YUCCA MOUNTAIN SITE CHARACTERIZATION PROJECT

RESPONSES TO STATE OF NEVADA LETTER ON THE SITE CHARACTERIZATION PLAN/ EXPLORATORY SHAFT FACILITY

DECEMBER 1990

U.S DEPARTMENT OF ENERGY'S COMMENT RESPONSES FOR THE PRELIMINARY
COMMENTS RECEIVED FROM THE STATE OF NEVADA

Figure 1. Inferred faults in the Coyote Wash area as interpreted by Smith and Ross (1982).

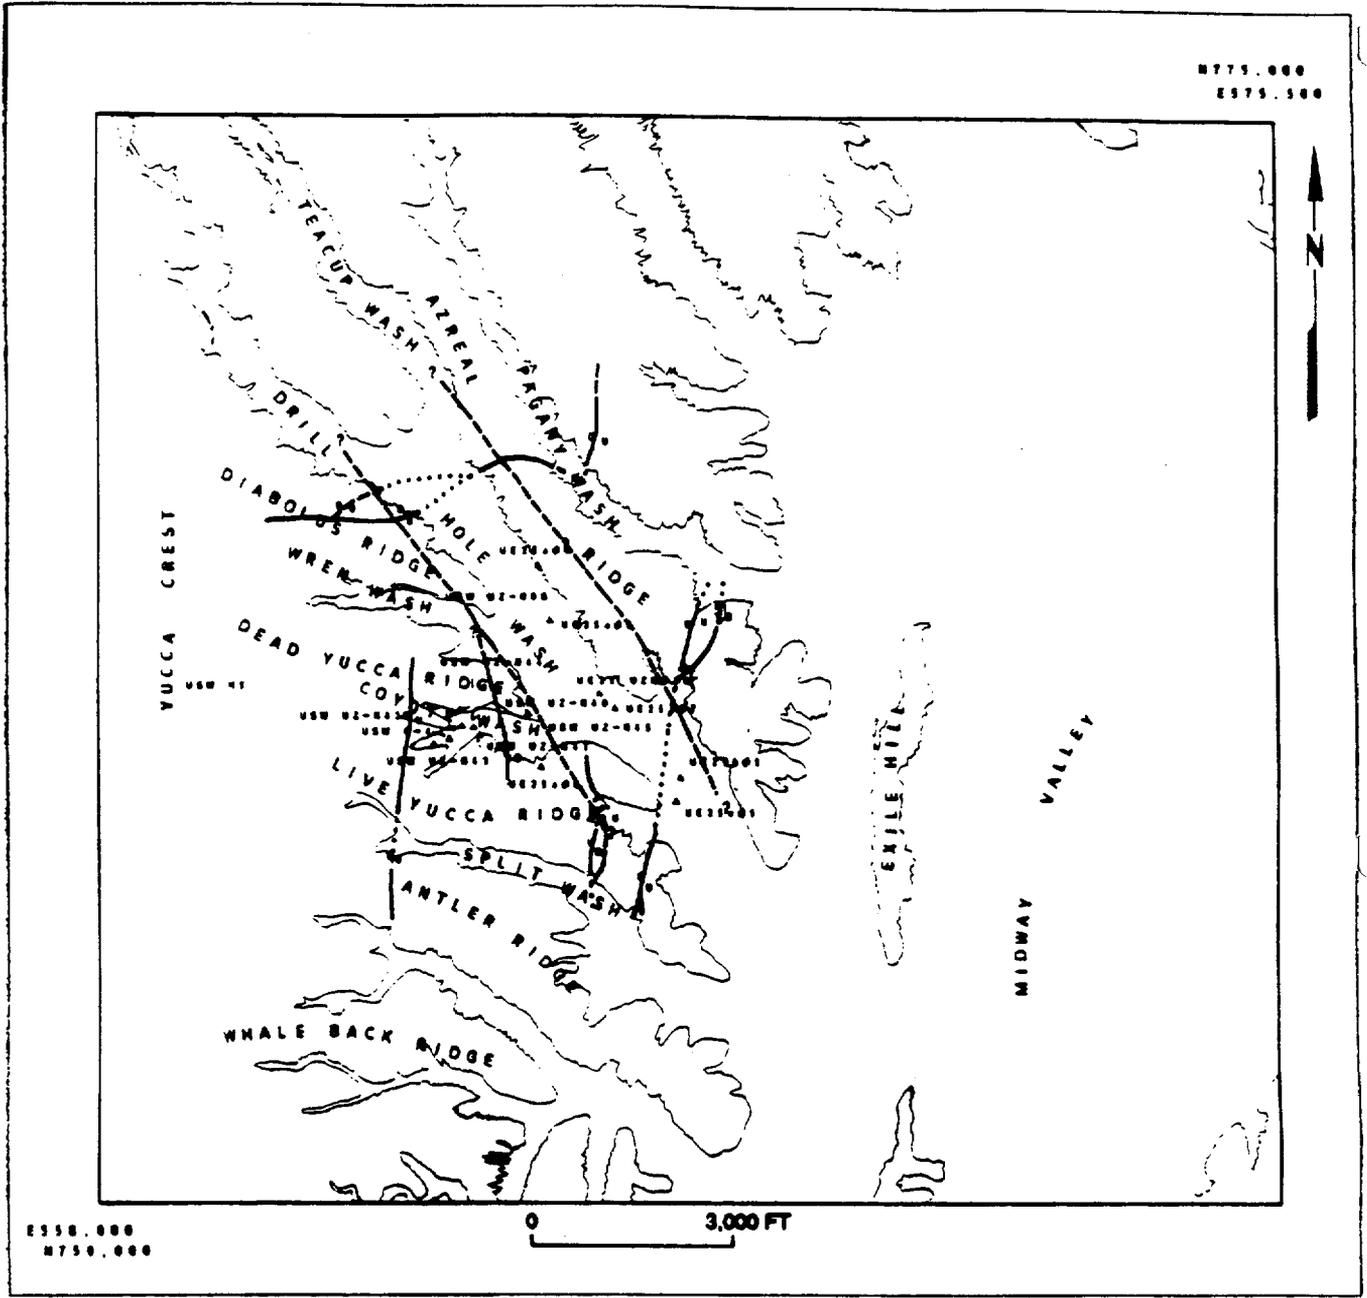
The known existence of a fault at the Coyote Wash ESF site would result in the disqualification of this proposed ESF site according to the criteria established in the 1982 Sandia ESF site screening report for setback from adverse subsurface geologic structures. Furthermore, placing the ESF in a fault-disturbed area casts into great question the representativeness of any site characterization data collected from the ESF. It also renders the ESF vulnerable to potential severe flooding from surface water infiltration along a preferred pathway, or from intersection of a perched groundwater zone during shaft or drift construction.

In addition to the fault/fracture zone inferred in Drill Hole Wash, Smith and Ross (1982) inferred the presence of a minor normal fault in Coyote Wash (Figure 1). This inferred fault was located about 400 meters (1,300 feet) east of Ghost Dance fault and was inferred to be downthrown to the east.
